Class II Permissive Change Letter

FCC ID Certification No.: 2AUDF-DB2

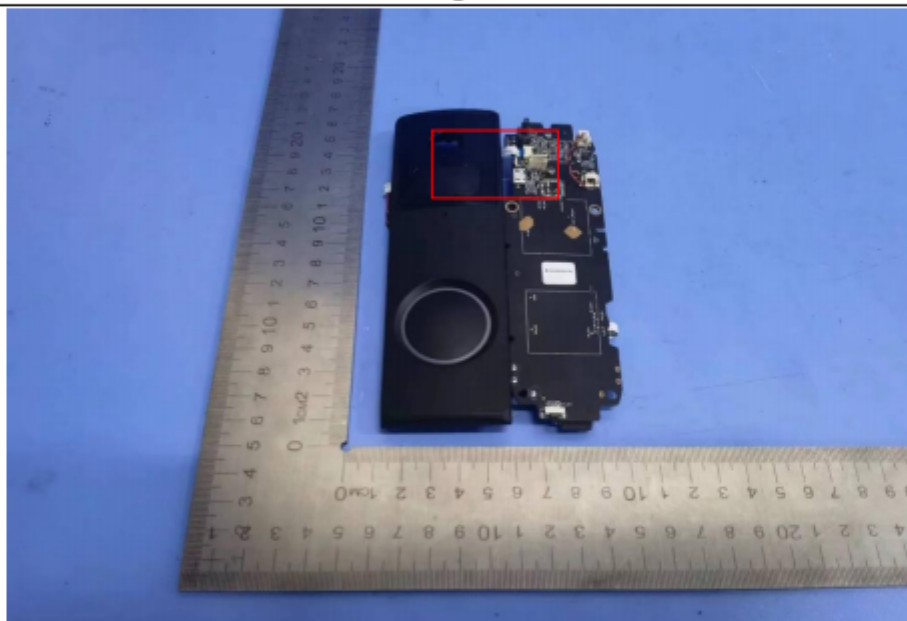
1. Change the Charging port Micro USB to Type-C USB, And optimized their matching circuit
2. Change the Battery capacity FXN123788/5000mAh and px123788/5000mAh to 4000mAh
